Joint Mequon-Thiensville Bike and Pedestrian Way Commission

TO: Joint Mequon-Thiensville Bike and Pedestrian Way Commission
FROM: Kristen Lundeen, Director of Public Works/City Engineer
DATE: January 14, 2021
SUBJECT: Highland Road Bike/Pedestrian Spur

Highland Road Bike/Pedestrian Spur

Highland Road Right-of-Way(PDF)

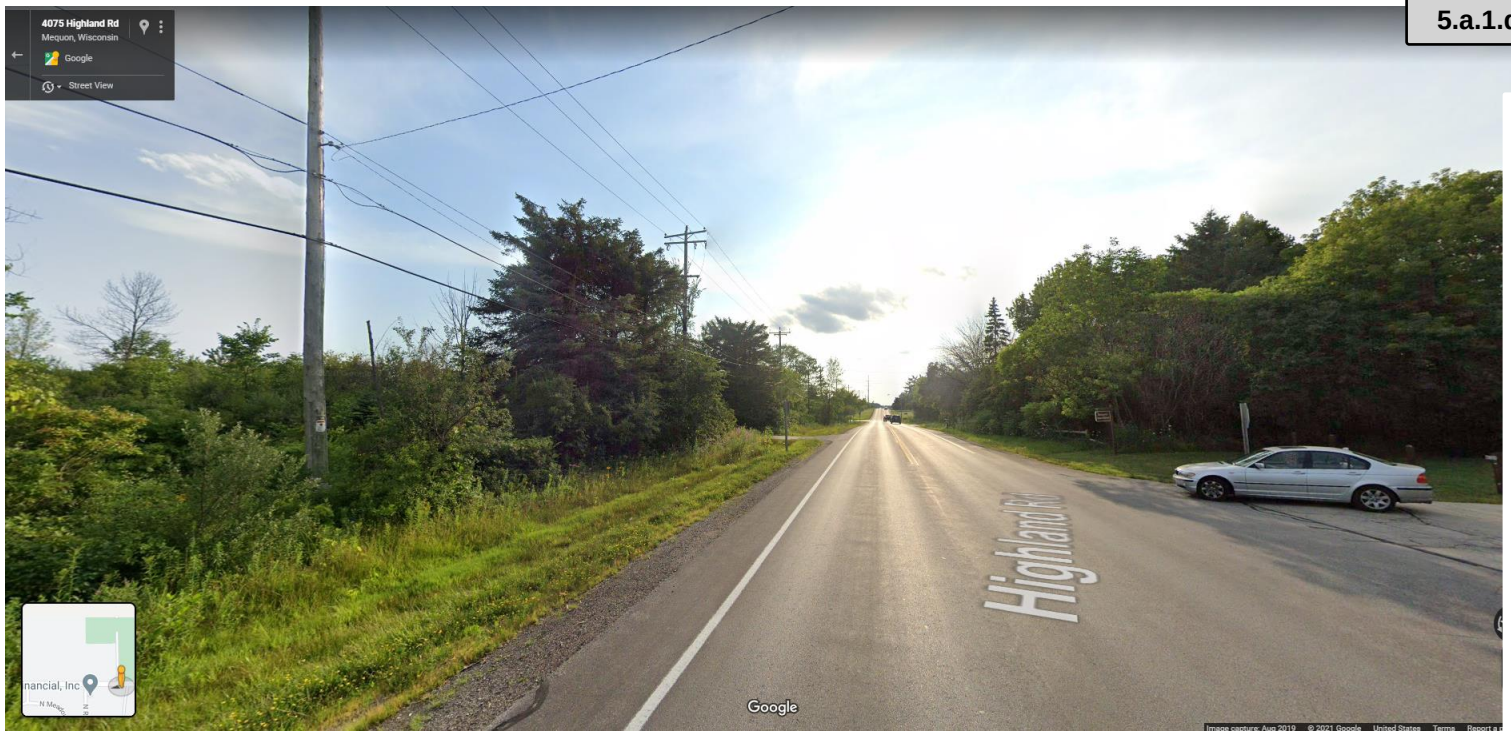
Note:

- Proposal does not contemplate connection to the east driveway

Note:

- Design should address the impact to existing landscaping and buffer

Note:

- The right-of-way may not be sufficient to allow a 10' path with two 1' shoulders and maintain existing drainage
- Modifying drainage may impact more than the right-of-way
- Drainage must be included in the design of the off-road path

Note:

- The right-of-way may not be sufficient to allow a 10' path with two 1' shoulders and maintain existing drainage
- Modifying drainage may impact more than the right-of-way
- Drainage must be included in the design of the off-road path

Note:

- The right-of-way may not be sufficient to allow a 10' path with two 1' shoulders and maintain existing drainage
- Modifying drainage may impact more than the right-of-way
- Drainage must be included in the design of the off-road path

Note:

- Design should address the impact to existing landscaping and buffer
- The right-of-way may not be sufficient to allow a 10' path with two 1' shoulders and maintain existing drainage
- Modifying drainage may impact more than the right-of-way
- Drainage must be included in the design of the off-road path

Note:

- The right-of-way may not be sufficient to allow a 10' path with two 1' shoulders and maintain existing drainage
- Modifying drainage may impact more than the right-of-way
- Drainage must be included in the design of the off-road path

Note:

- Potential for utility conflict at the intersection.
- The design for the proposed crosswalk should consider existing intersection design.
- The right-of-way may not be sufficient to allow a 10' path with two 1' shoulders and maintain existing drainage
- Modifying drainage may impact more than the right-of-way
- Drainage must be included in the design of the off-road path

Note:

- Potential for utility conflicts.
- The design for the proposed crosswalk should consider existing intersection design.
- The right-of-way may not be sufficient to allow a 10' path with two 1' shoulders and maintain existing drainage
- Modifying drainage may impact more than the right-of-way
- Drainage must be included in the design of the off-road path

Note:

- Potential for utility conflicts.
- The right-of-way may not be sufficient to allow a 10' path with two 1' shoulders and maintain existing drainage
- Modifying drainage may impact more than the right-of-way
- Drainage must be included in the design of the off-road path
